## **CALIFORNIA COASTAL COMMISSION**

# **F8a**

**A-2-SMC-19-0002 (Zubieta SFD)**

**August 14, 2020**

|  <p>CARLOS ZUBIETA ARCHITECTS</p> |  | <p>ASSESSOR'S PARCEL NUMBER:<br/>037-123-430</p> <p>REVISIONS PER CDCR HEARING COMMENTS 07.24.17</p> | <p>PROJECT ADDRESS:<br/>199 ARBOR LANE, MOSS BEACH, SAN MATEO COUNTY, CA</p> <p>SITE PLAN</p> | <p>A1.0</p> |

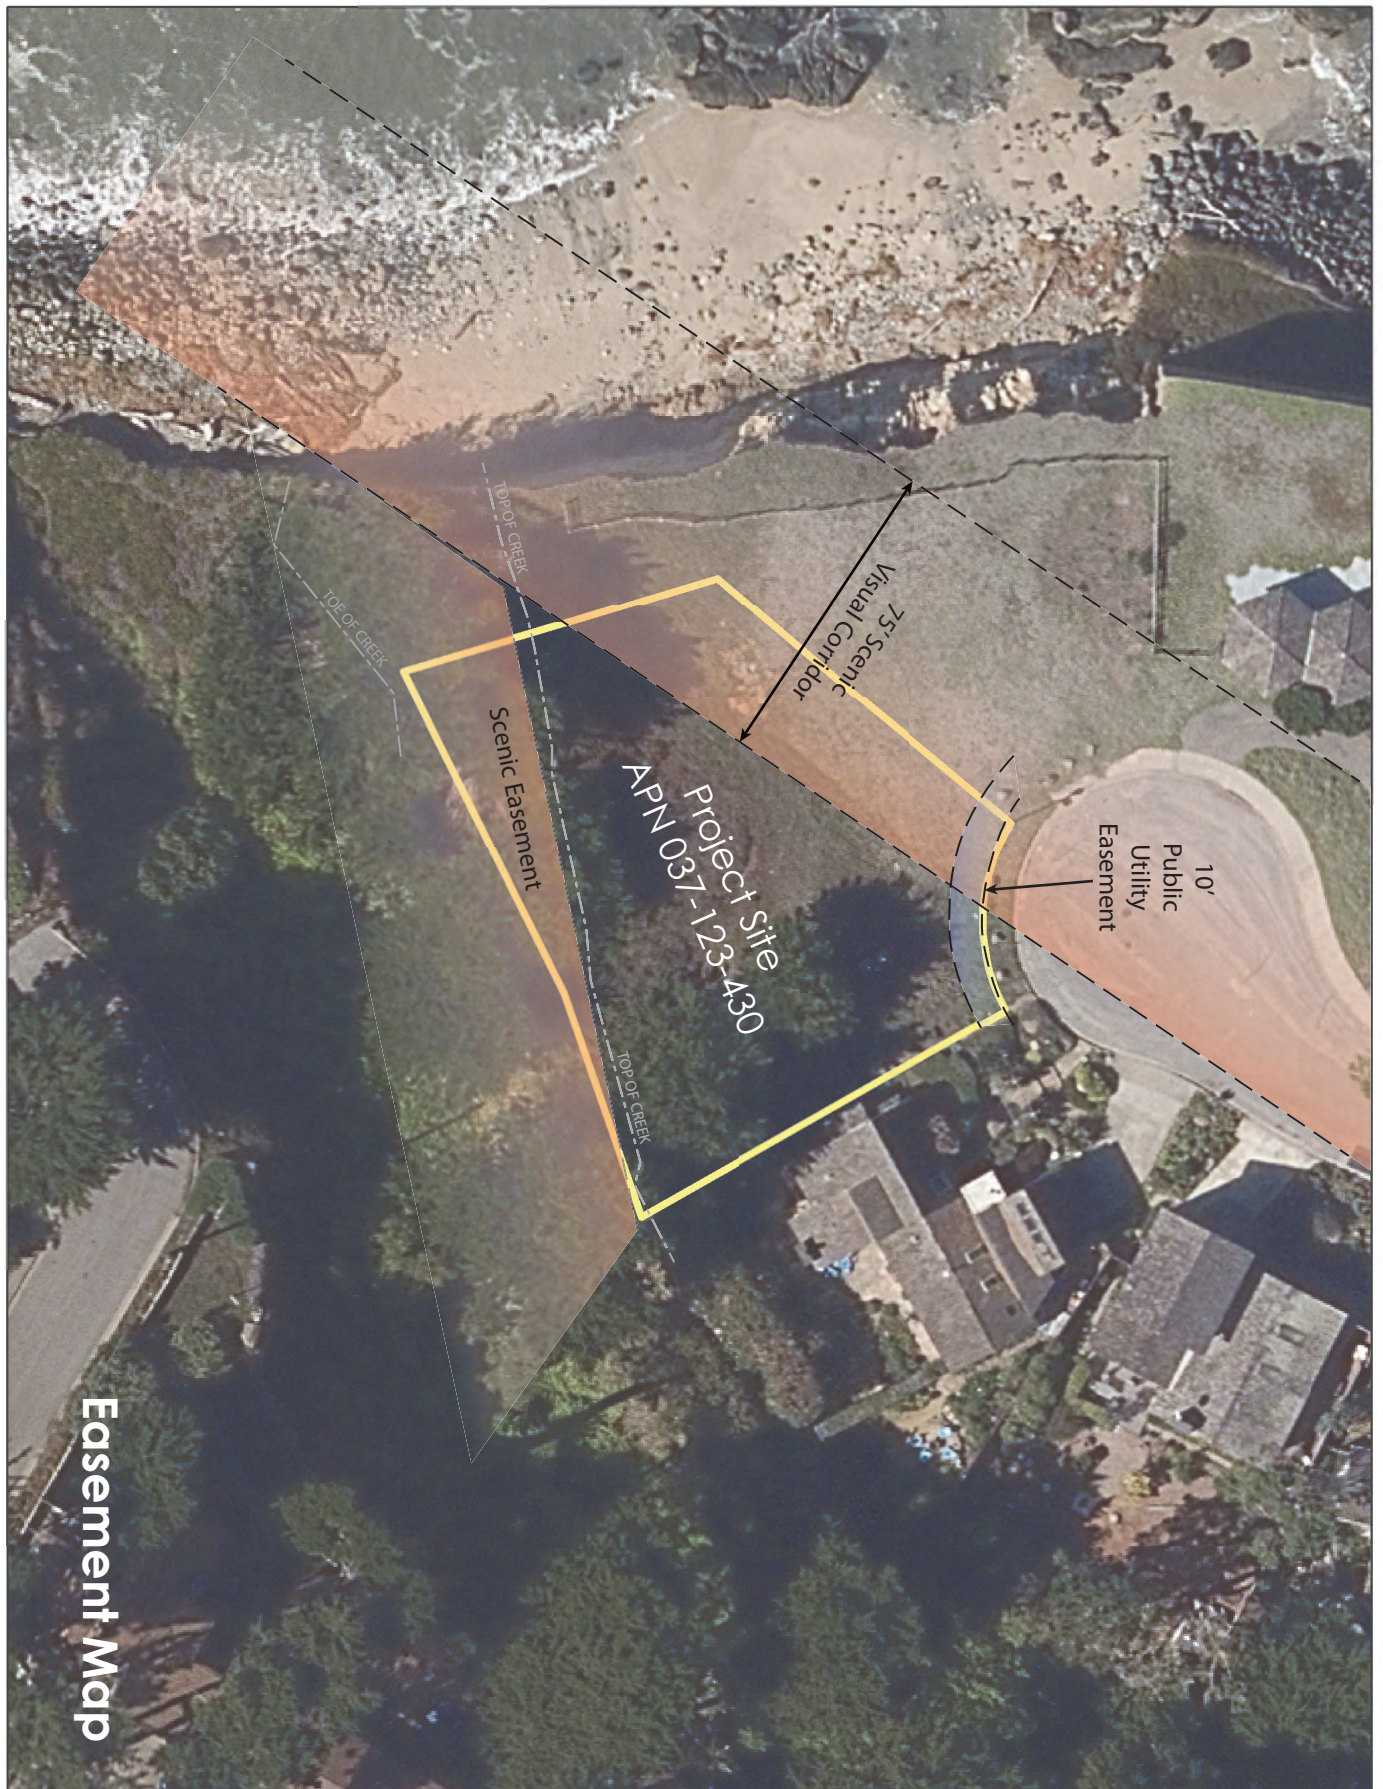
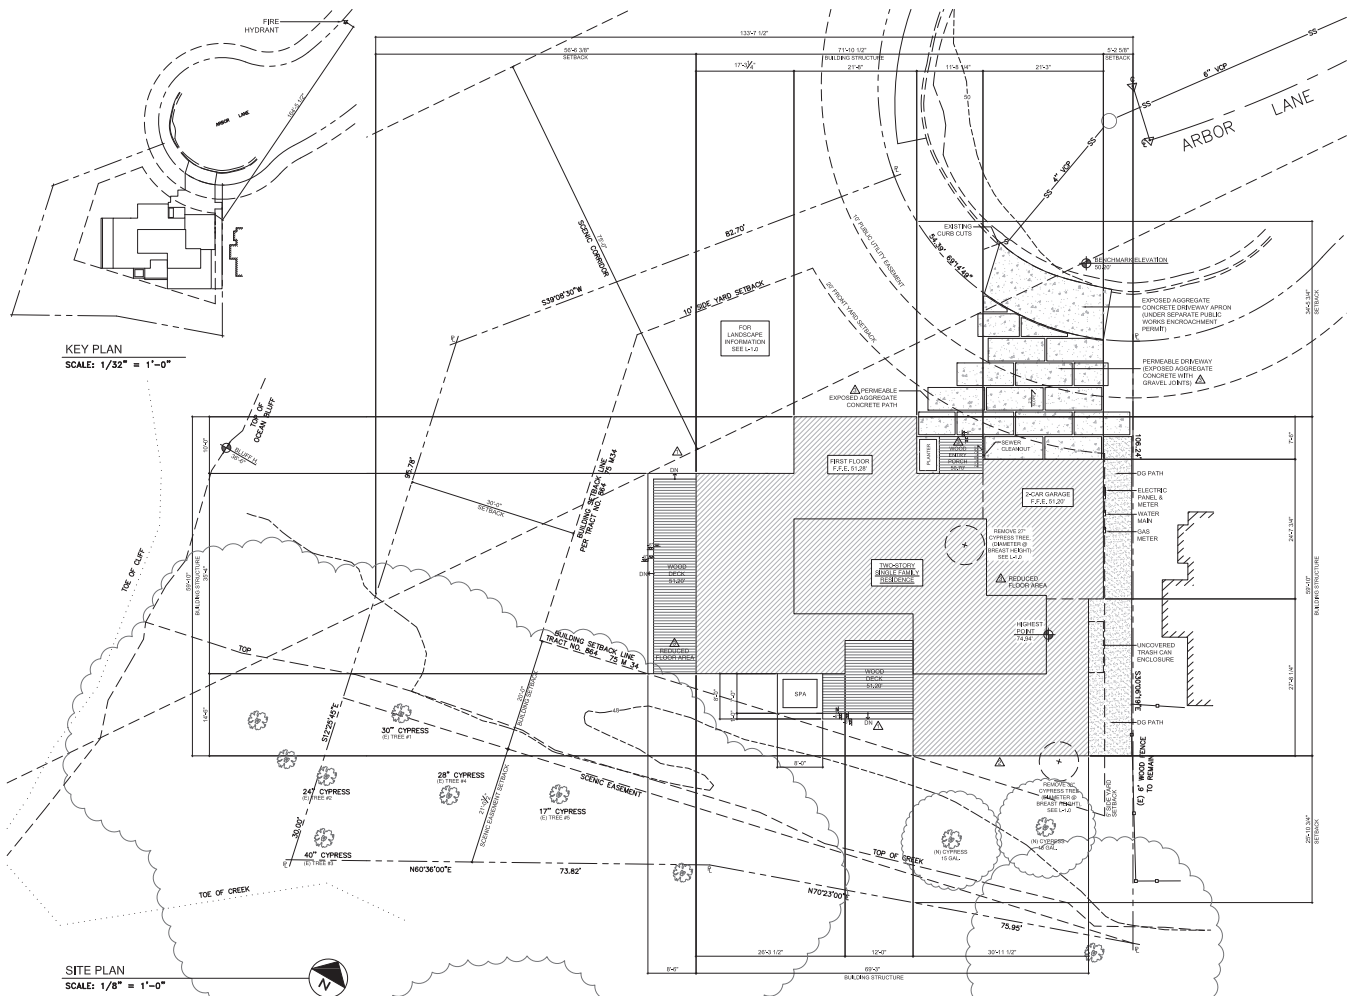
**Ocean cliff/bluff retreat analysis** for the project used bluff setback measured perpendicular to the west side of the residence (78 feet), but the top of bluff is not parallel to the residence. Per the site plan, the shortest distance from top of bluff to NW corner of development is only 72 feet. Coastal bluff episodic erosional process was demonstrated most recently with the major bluff retreat measured after winter 2016/17 storms (noted in Michelucci 8/29/17 report, but not updated on the site plan survey). Reported measurements indicate six feet of bluff were lost on the south end and 11 feet were lost on the north end of the proposed development area. Using this information, the NW corner of the proposed development is now 61 feet from the bluff top. Accordingly, the calculations for estimated bluff retreat timeline should use 61 feet instead of 78 feet for the existing setback from the top of bluff:

**Figure 14**

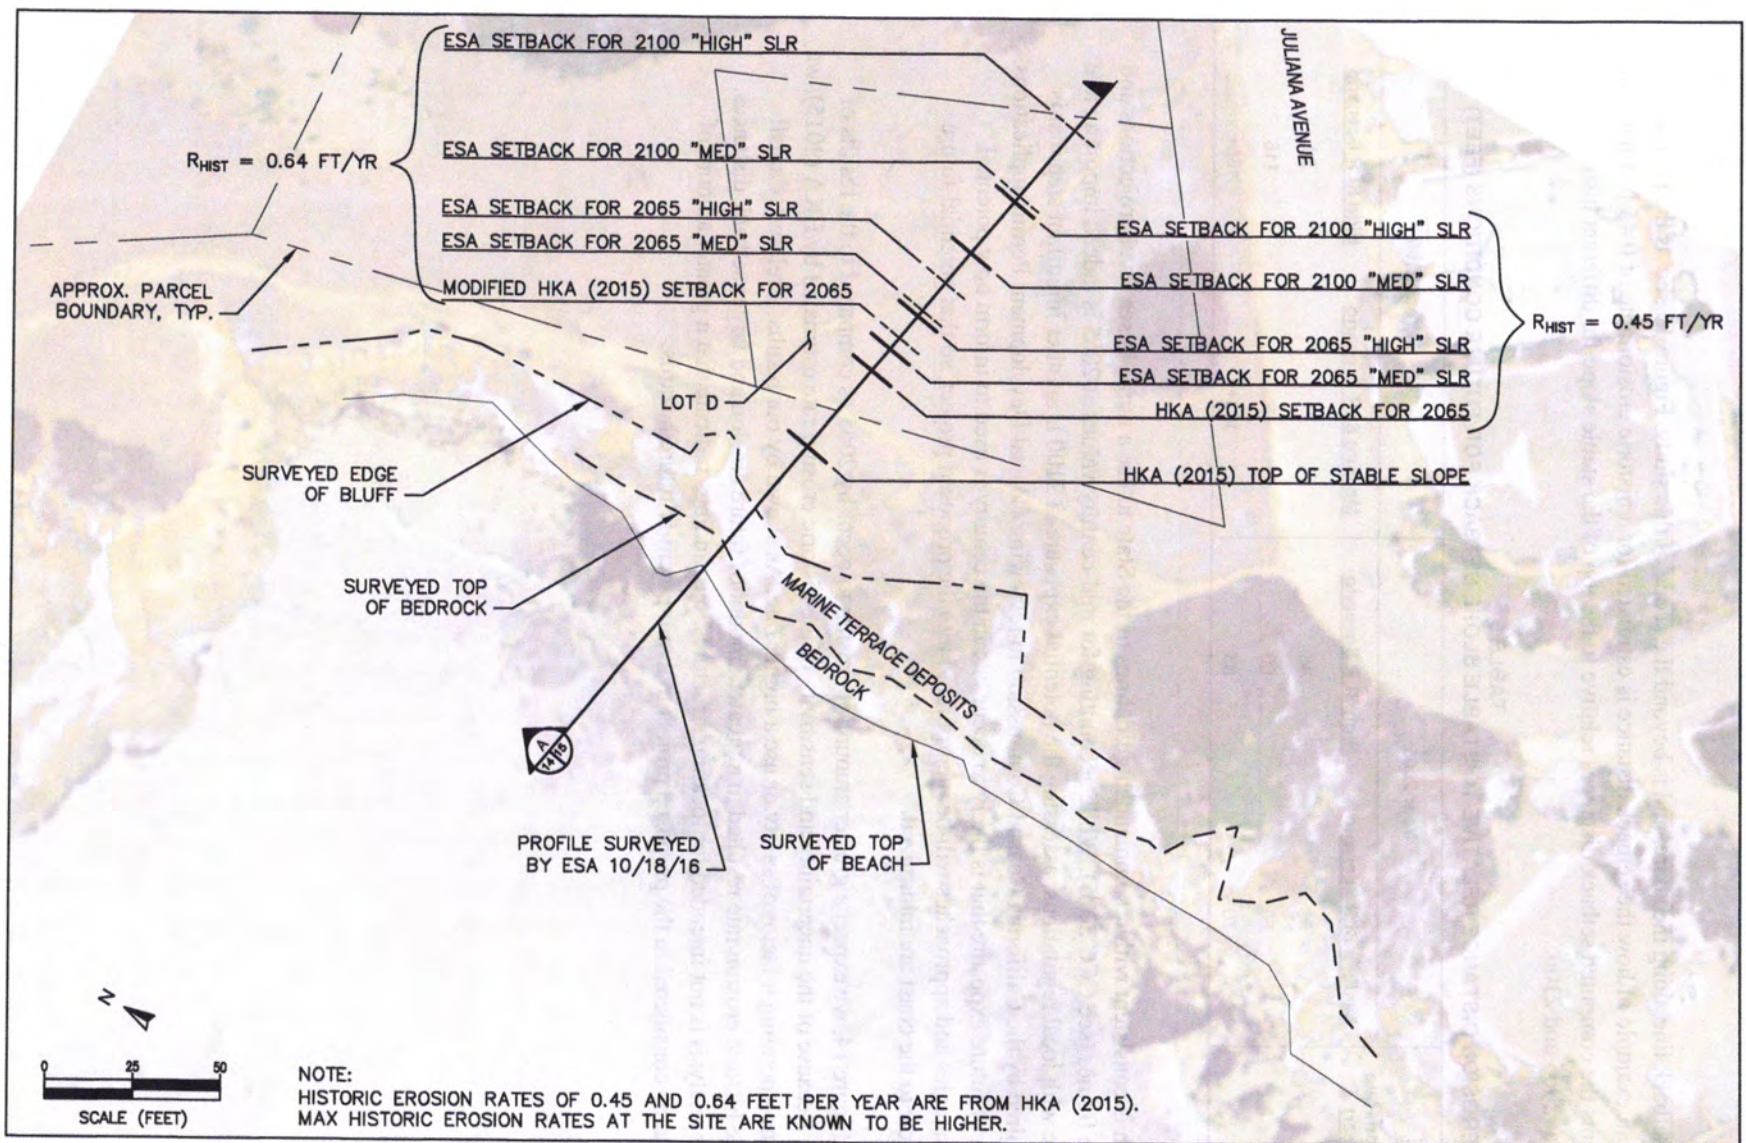
Figure 14 presents a plan view of the stable slope location and the computed setbacks associated with the medium and high SLR scenarios at 2065 and 2100 for two historic erosion rates. The setbacks shown with the solid lines are based on a historic erosion rate of 0.45 feet per year, and those with the dashed line are based on a historic erosion rate of 0.64 feet per year. These setback distances are applicable to the surveyed profile location only, and may not be representative of appropriate setback distances along the shore. Additional work is required to

As shown in Figure 14, we expect a greater amount of erosion to occur by 2065 as compared to the results of HKA (2015). Because of the uncertainty and sensitivity of the historic erosion rate estimated by HKA (2015), we recommend incorporating a factor of safety or use a higher rate. As shown by our results, a relatively small increase in the historic erosion rate resulted in a greater amount of future erosion and larger setback distances. Although this analysis is not intended for locating structures, our findings indicate that a greater amount of erosion should be considered in the proposed project to avoid potential future hazards.

**Figure 15**

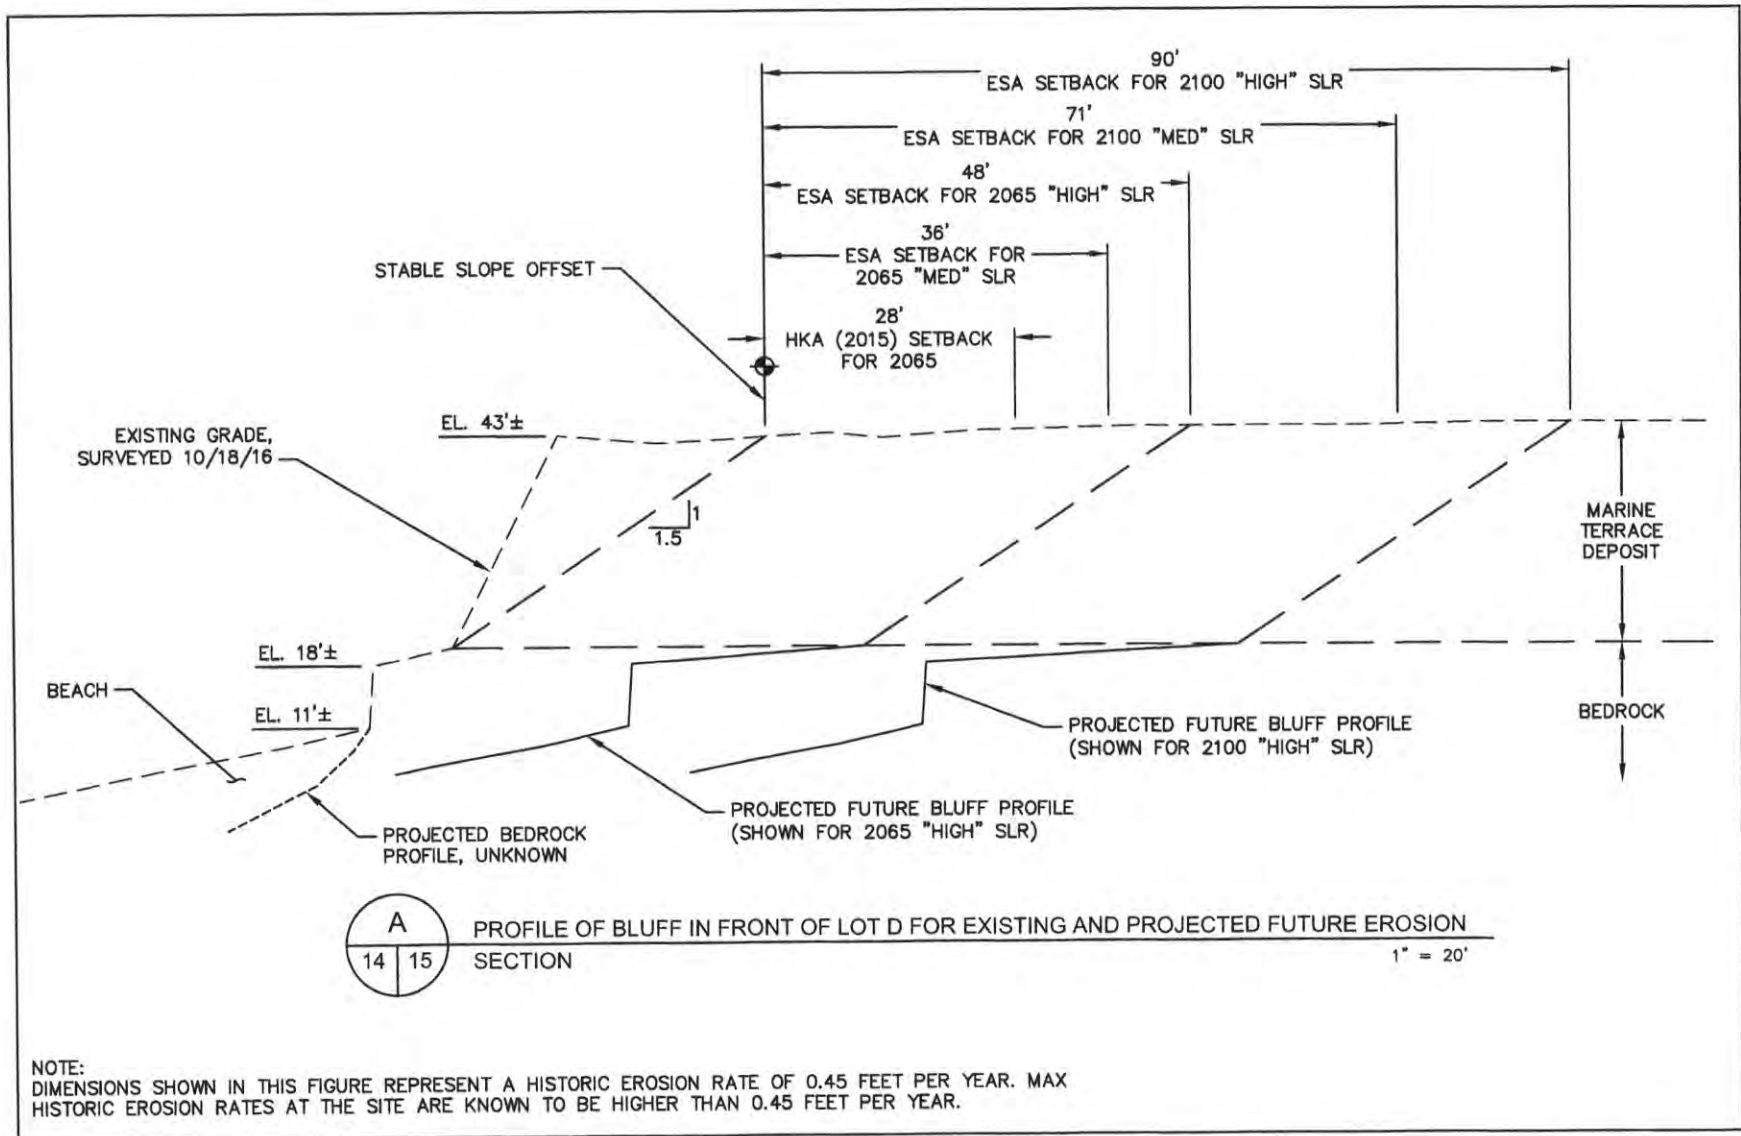
compute the setback line along the shore, and is beyond the scope of this study. Figure 15 shows the profile section, with an example of how the setback distance is estimated for a historic erosion rate of 0.45 feet per year. Table 5 presents the computed setback distances relative to the top of the stable slope for different historic erosion rates at 2065 and 2100.
